TECH TALK

WIX WL10025

OE OX 813/1
BMW 11428575211

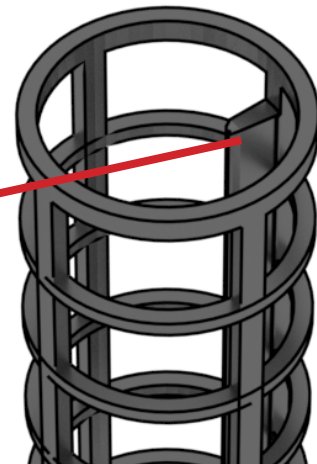
The WIX WL10025 is not a suitable replacement filter for applications requiring the OE filter OX 813/1 (BMW 11428575211). The OX 813/1 has an alignment tab inside of the filter center tube. The tab fits into a slot in the oil housing ensuring proper alignment during filter installation. The WIX WL10025 does not have the alignment tab and can be installed incorrectly resulting in low oil pressure during vehicle operation.

Filter Housing

Center Tube Align Tab

The correct WIX replacement filter for the OE OX813/1 (BMW 11428575211) is the soon to be available WIX WL10358.
